HISTORIC PRESERVATION BOARD STAFF REPORT

46 Marine Way		
Meeting	File No.	Application Type
June 3, 2026	HP-544-2026	Certificate of Appropriateness, Demolition, Relocation, Variances, & Waivers

The item before the Board for consideration of a Certificate of Appropriateness (HP-544-2026), Demolition, Relocation, Variances, & Waivers in association with the vertical relocation, alteration and additions to the existing main contributing structure and demolition of the accessory contributing structure for the property located at **46 Marine Way, Marina Historic District**.

Proposed
Coral
Feature
(Front
Elevation)

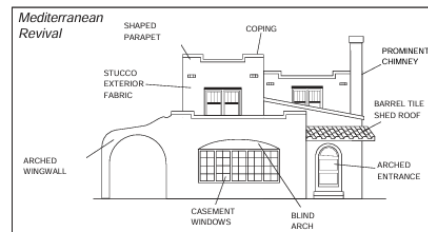
There is some concern regarding the **Rhythm of Entrance and/or Porch Projections** and **Directional Expression Of The Front Elevation** as the original main structure is no longer prominent due to the addition being substantially larger, in addition to the new ground level beneath to accommodate FEMA requirements. The addition, however, is recessed behind the entire existing structure, though a portion of it is highly visible from the adjacent Marine Way right-of-way. This does impact the structures appearance and rhythm from the street. The board will need to make a determination that the proposed additions are compatible with respect to the rhythm of entrance and/or porch projections and directional expression of the front elevation.

Waiver Request 1:

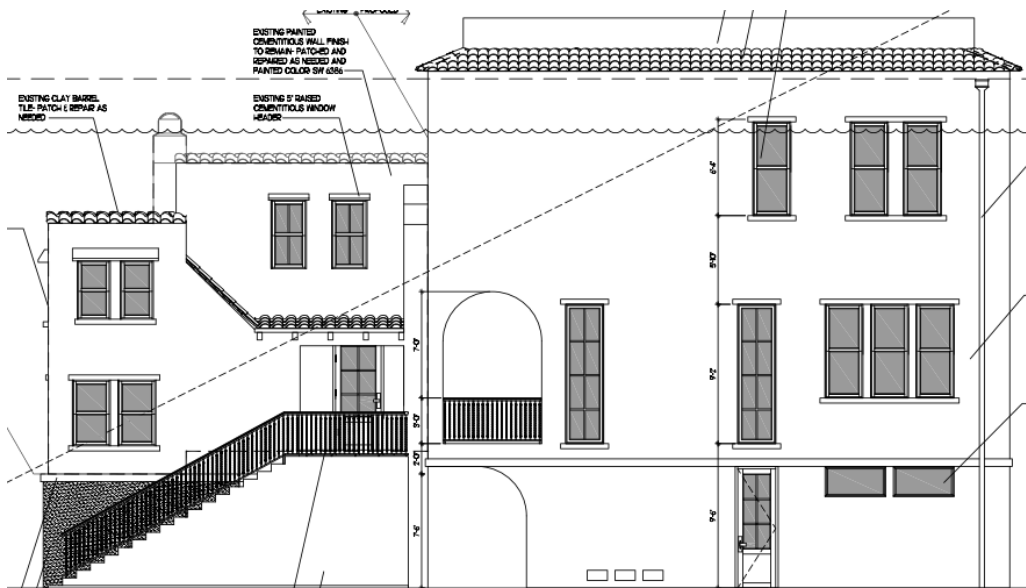
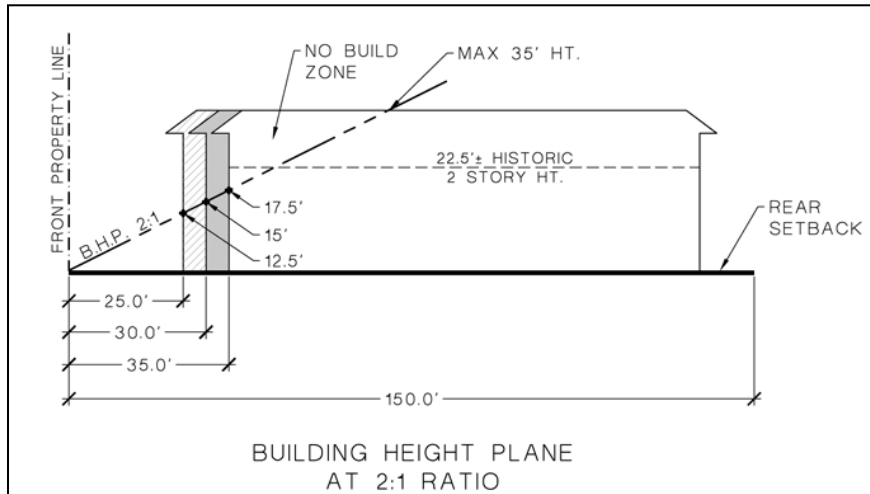
The Waiver request is to allow the existing vertically elevated structure and portions of the two-story addition to encroach within the required 2:1 Building Height Plane (BHP) ratio.

A large portion of the historic structure and portion of the new two-story addition fall within the "No Build Zone" of the BHP. It may not be possible to elevate the existing two-story structure to the minimum FEMA finished floor requirements without seeking a waiver to this visual compatibility standard, however the design of an addition could comply. Consideration could be given to keeping the structure at its lowest possible elevation per FEMA, to reduce the amount of the structure within the "No Build Zone". Should the proposal have planned for a one or shorter two-story addition it would reduce the impact upon the historic district and adjacent streetscape. The board will need to determine if the waiver results in a special privilege and if the same waiver would be granted under similar circumstances on other property.
